Glen Innes to Tamaki Drive Shared Path: Summary of your feedback on Section 2 (St Johns Road to Ōrākei Basin)

February 2019

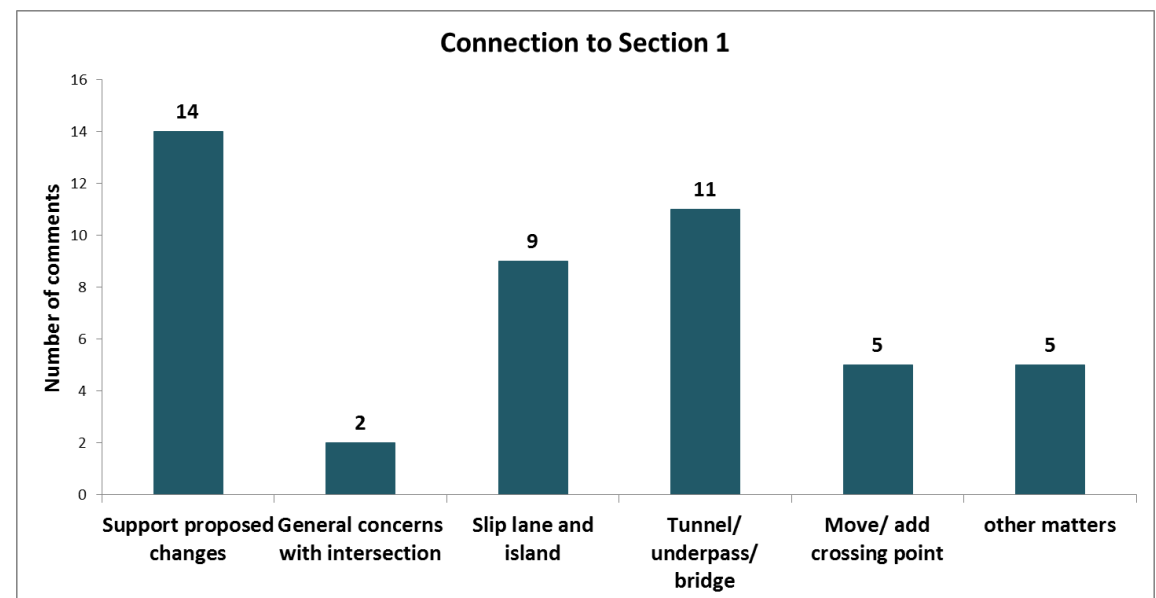
46 of you commented on this connection (21% of those commenting on connections); many of you noting that the intersection was difficult to cross and unsafe. 14 of you welcomed the proposed changes and two expressed residual (general) concerns. In addition, there were 30 requests for further specific change:

- 11 of your comments expressed a desire for a grade separated crossing such as an underpass or bridge (one person noting an underpass would also assist horse riders).

- We received nine requests for the removal of the slip lane or raising questions around the suitability of the island. The slip lane was generally seen as unsafe, and the enlarged island insufficient for cyclists and horses.
- There were five requests to move the crossing or to add a crossing on the northern side of the intersection. Other comments included your identified need to provide better cycling access along the adjacent connecting roads (e.g. St Heliers, West Tamaki Roads) as these were narrow in places and made accessing the path dangerous.

Aspect	Number of comments <i>(break-down within theme)</i>	Feedback points	Auckland Transport/NZ Transport Agency response
Route (Section 4)	2	<ul style="list-style-type: none"> ▪ Prioritise Section 4 (1) ▪ Interim solution required for Section 4 (1) 	<p>The routes along the railway lines for Section 4 were discounted as part of an earlier process and so have not been considered further.</p> <p>The design for Section 4 is in development and we are aiming to complete both Section 2 and 4 by the end of 2021.</p>
Connections	29	<p>Connection with Section 1 (St Heliers Bay Road and St Johns Road intersection):</p> <ul style="list-style-type: none"> ▪ Grade separate intersection (11) ▪ Remove slip lane (9) ▪ Move crossing/add crossing on north of intersection (5) ▪ Provide zebra crossing (1) ▪ Widen/ improve cycling access on St Heliers Bay Road (1) ▪ Improve cycling access on West Tamaki Road (1) ▪ Stop changing/disrupting intersection (1) 	<p>The pedestrian crossing over the slip lane on St Heliers Bay Road will be 5.4m wide and it will be a raised crossing. Half of the crossing will be green for people on bikes and half of it marked with zebra stripes for pedestrians.</p> <p>Removing the slip lane and adding additional pedestrian crossings would have a major effect on the operation of the intersection and a change of this scale needs to be addressed as part of a broader work programme, taking into consideration to traffic flow in the wider area. This is not within the scope of this project and any major changes will be addressed through the <u>Integrated Corridors Programme</u>.</p> <p>The size of the traffic Island will be increased by 250%, from</p>

Aspect	Number of comments <i>(break-down within theme)</i>	Feedback points	Auckland Transport/NZ Transport Agency response
			<p>13m² to 46m². (measured as the path area, not the whole area of the island). This will provide a good amount of space for people on bikes and on foot.</p> <p>Improvements to surrounding cycling infrastructure, such as on West Tamaki Rd, are not within the scope of this project. There are no current plans for plans for cycling improvements on West Tamaki Road. This area is not identified in the Cycling Programme Business Case as ‘priority area’, however cycling improvements here may be undertaken as part of other transport projects.</p>
	153	<p>North-South connections:</p> <ul style="list-style-type: none"> ▪ Increase access (19) ▪ Access to: <ul style="list-style-type: none"> – Eastridge shops (8) – schools (46) – train station from Kepa Rd (8) – Kepa bush (5) – Purewa Cemetery (2) 	<p>We acknowledge that the community are eager to have north-south connections through the reserve. While connections to the shared path are not in the scope of this project, when designing and constructing the shared path, care is taken to ensure that future connections are possible. Auckland Transport and Auckland Council are responsible for local links and are working with the local board on links in some areas. Available budget and prioritisation are issues</p>

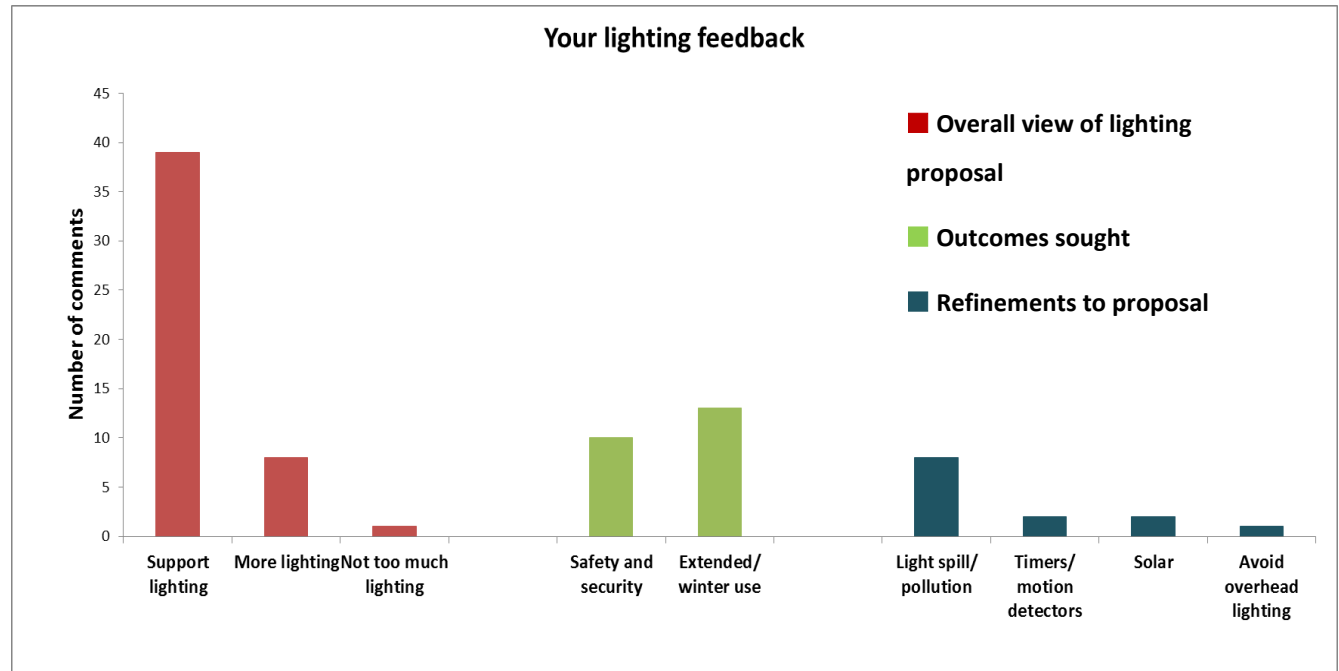
supportive of our proposed approach and underlined our identified objectives of improving both safety and the use of the path. Eight of you wanted to see more lighting, and one person cautioned that there should not be too much lighting.

We received 13 suggested refinements to the lighting proposal; most of these (eight) were concerned with light spill into neighbouring properties, light pollution effects upon the surrounding bush, and the brightness of LEDs. We received one request that there be some illumination a short distance beyond the path to assist with security and safety. Closely related to this were two suggestions to install timers or motion detectors. Two of you encouraged the use of solar powered lighting, and one requested we avoid overhead lighting and use low-level lighting instead.

Aspect	Number of comments <i>(break-down within theme)</i>	Feedback points	Auckland Transport/NZ Transport Agency response
		<ul style="list-style-type: none"> ▪ Address potential light spill into properties neighbouring the path, light pollution, brightness of LEDs (8) ▪ Install timers/motion detectors (2) ▪ Use solar lighting (2) ▪ Avoid overhead lighting/use low-level lighting (1) 	<p>lighting under the handrail, which means light spill will be minimal on adjacent properties.</p> <p>Alongside the concrete sections of the path we will install lighting columns, which will be angled to ensure light does not spill onto neighbouring properties. Once we have determined where lighting columns are likely to go, we will share plans with adjacent neighbour/s.</p> <p>LED lighting will be used in handrails on bridges and boardwalks and LED luminaires on the lighting columns. LED lights have significantly longer life expectancy than other types of lighting, they use a fraction of the power consumption of incandescent lighting, and provide a more natural spectrum compared to sodium lamps.</p>

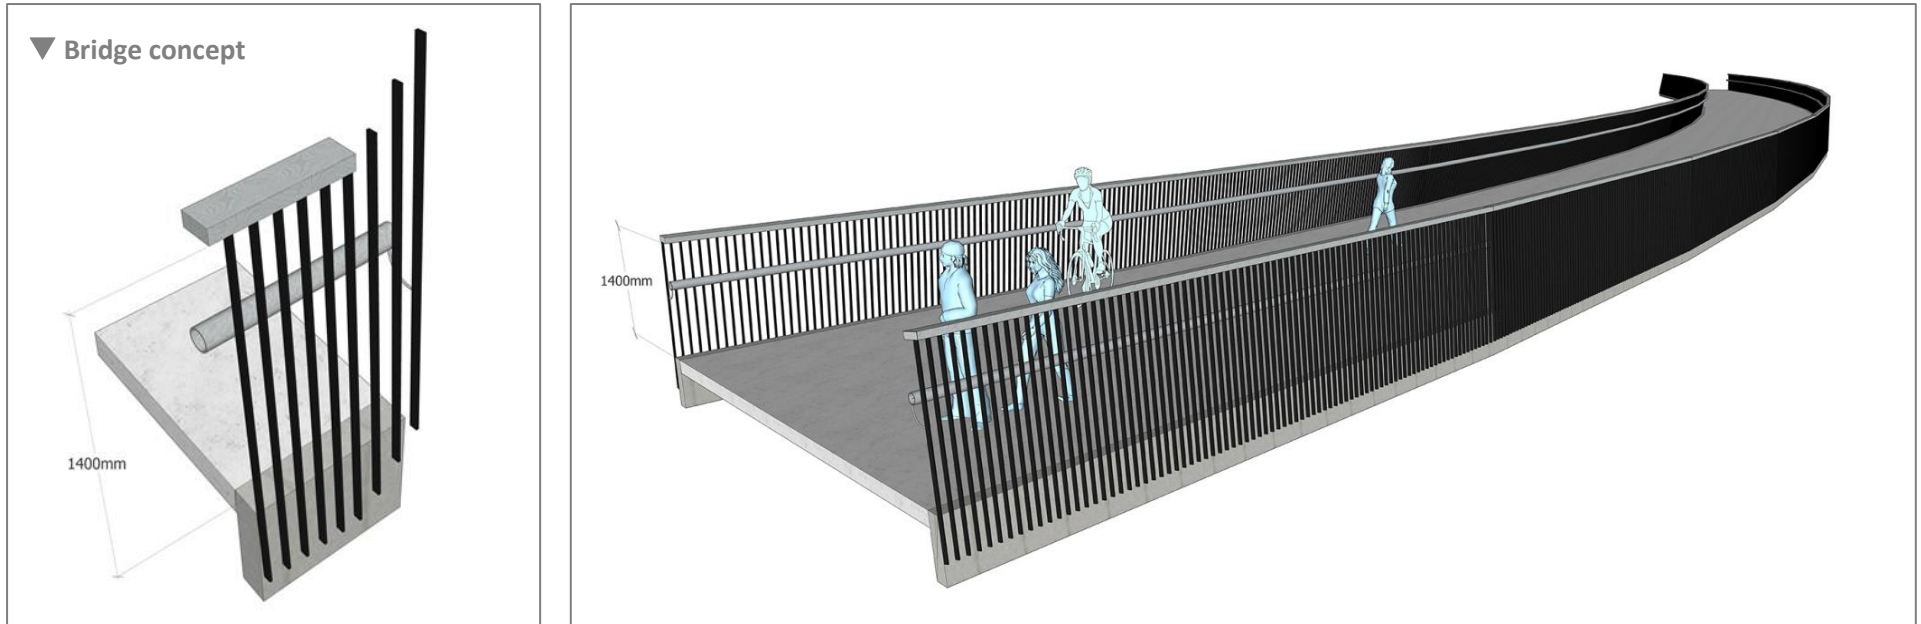
We received comments from 34 of you on the landings. Four of you suggested some modification without expressing a preference. However:

- have landings as a lay-by or across only part of the path (3);
- ensure the landing design does not compromise safety (2);
- make the landings as far apart as possible (1).
- make sure the landings provide refuge as intended (2);
- mark the landings to indicate a change in slope (2);

“The landings should be visually indicated with markings on the surface - hitting them unexpectedly on a downhill will cause jarring of the joints and possibly falls.”

Aspect	Number of comments <i>(break-down within theme)</i>	Feedback points	Auckland Transport/NZ Transport Agency response
		(2).	include creating connections to the shared path. Tahapa Reserve East will serve as a key access point and laydown area for the duration of our construction works. We are working with Council to coordinate these works.
	3	<ul style="list-style-type: none"> ▪ Include 'Maori features' (2) ▪ Not sure about Maori features/include other stories (1) 	Auckland Transport has engaged Maori artists (kaimahi toi) to design cultural artworks for the project. These elements are still being developed in consultation with mana whenua but are likely to include pou, carved handrails, concrete stencils in the path and perforated metal in the rail overbridge.
Engineered elements	36	Landings: <ul style="list-style-type: none"> ▪ resolve feedback on landings (15 for: 15 dislike/have concerns) ▪ have landings as a lay-by or across only part of the path (3); ▪ ensure the landing design does not compromise safety (2); 	We listened to feedback about the spacing between landings on Section 1 and have designed longer, more widely-spaced landings for Section 2. This should provide a smoother ride for people on bikes and people using mobility aids. A different finish on the landings is proposed to provide a visual cue to path users. The finish on the landing will be

Aspect	Number of comments <i>(break-down within theme)</i>	Feedback points	Auckland Transport/NZ Transport Agency response
		<ul style="list-style-type: none"> ▪ make the landings as far apart as possible (1) 	<p>dark exposed aggregate concrete and on the path it will be lighter grey concrete with a ‘broom brush’ finish.</p> <p>The spacing of landings varies depending on the gradient. For steeper gradients, the landings need to be more closely spaced. The shortest distance between landings is 10 metres — this is in a short, 80 metre section. Otherwise the typical spacing is 45 metres or more, compared to a nine metre spacing on Section 1.</p>
	53	<p>Bridges and boardwalks:</p> <ul style="list-style-type: none"> ▪ Make bridges a feature (2) ▪ Change bridge decking (1) ▪ Change boardwalk decking (8) ▪ Minimise height/extent of balustrades (17) ▪ Balustrades consistent across project (5) ▪ Change balustrade materials (12) ▪ Balustrades dark/black/natural colour (3) ▪ Use non-slip surfaces (6) 	<p>The fibre reinforced plastic decking we propose on the boardwalk sections has been selected for its durability and grip. The bridges will have concrete decks. Concrete is also durable, has good grip and slip resistance, and is low maintenance.</p> <p>Balustrades will be used where the path is on a steep gradient - this provides for mobility impaired users to be able to hold onto a handrail and also where there is a fall from height risk (to protect people from falling down a steep</p>

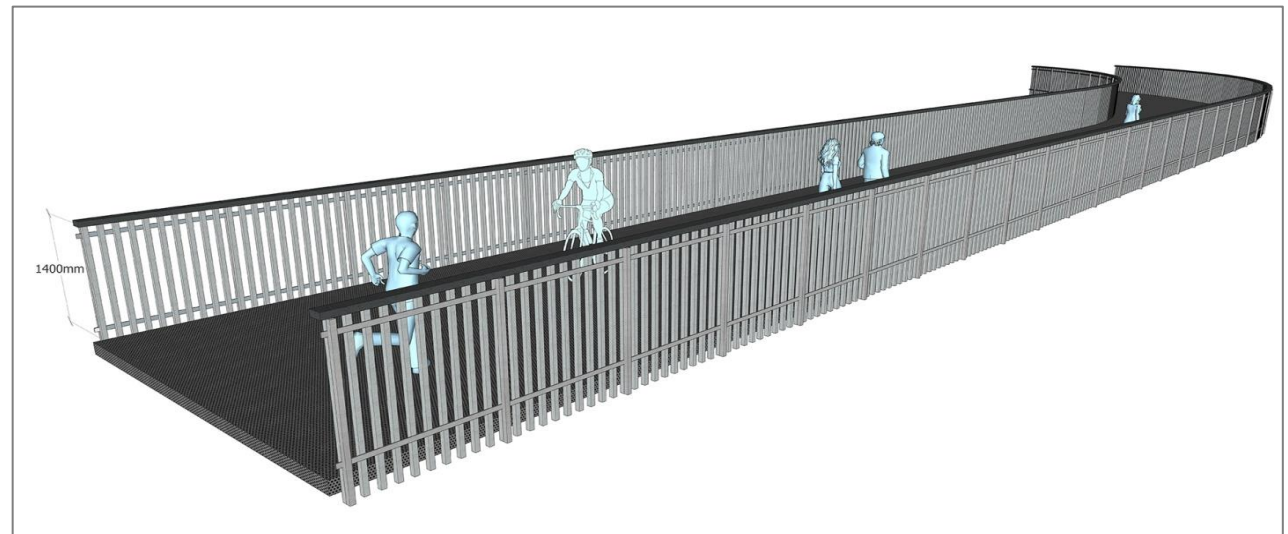
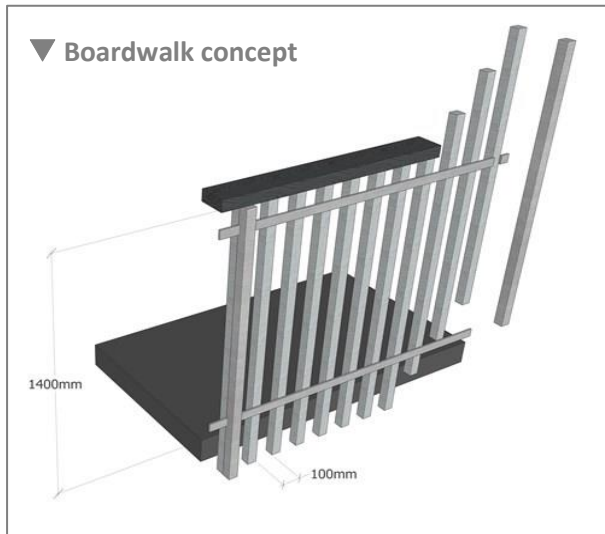
“I don't like the boardwalk and bridge railing designs. I think they are too high and obscure the beautiful view.”

“I think railing style should be consistent to what you have on the boardwalk.”

There were 88 comments on the structures, as shown in the table overleaf. Overall, the bridge concept is supported and more of you liked the idea of a boardwalk than not. Nearly half of your comments related to refinements of common elements such as the balustrades, and notably their height.

Aspect	Number of comments <i>(break-down within theme)</i>	Feedback points	Auckland Transport/NZ Transport Agency response
			<p>slope / drop).</p> <p>We are reviewing the 1.4m balustrade height for Section 2 to see if there are areas where this can safely be reduced to 1.2m and are considering factors such as the straightness of the path, forward visibility, lighting and presence of hazards (e.g. one of the bridges crosses over the railway lines which are electrified). We will be sharing the final design with you and balustrade height/s will be confirmed at this time.</p>
	6	<p>Fences:</p> <ul style="list-style-type: none"> ▪ Make fence smaller and less obstructive, not post and wire (5) ▪ Make fence more substantial (1) 	<p>We are working with the Pony Club to ensure the post and wire fence in this location is suitable for horses.</p>
	15	<p>Path:</p> <ul style="list-style-type: none"> ▪ Path not wide enough (2) ▪ Path too wide (1) ▪ More detail required (3) ▪ Off path space to run on (1) 	<p>The shared path will be mostly 4m wide, increasing to 4.5m on boardwalks and bridges, which is consistent with the widths on the other sections of the route.</p> <p>The paths will be concrete, which is durable, has good grip and slip resistance, and is low maintenance.</p>

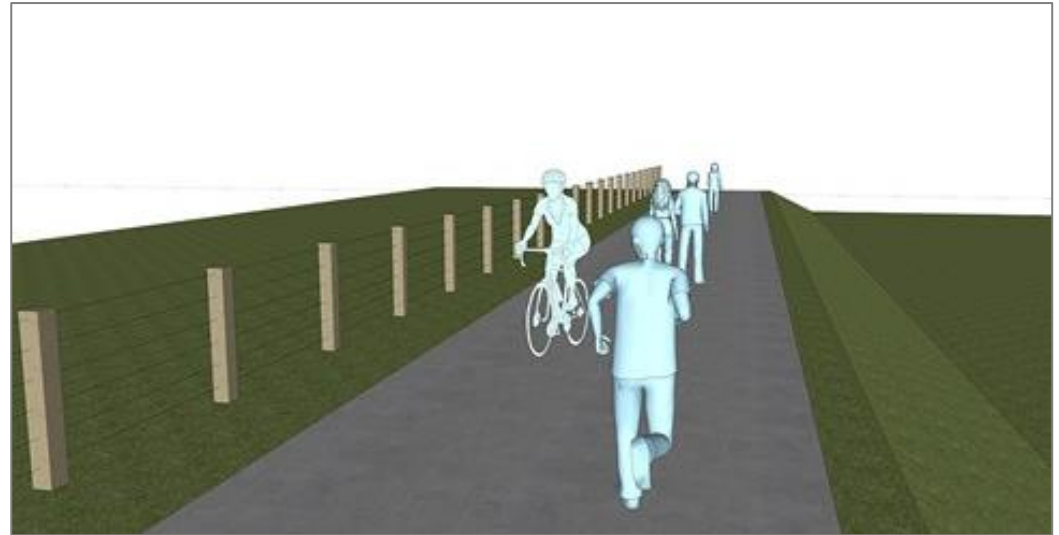
- Seven of you liked the proposed fence because it would not be intrusive and would give *“good visual permeability and connection to this 'rural' land”*, and was in keeping with the pony club context.
- Five of you thought a different approach was required and that the fence should not be a post and wire fence, that it was too high/should be even smaller and *“less obstructing to the eye”*. By contrast, one person thought the fence should be made more substantial.
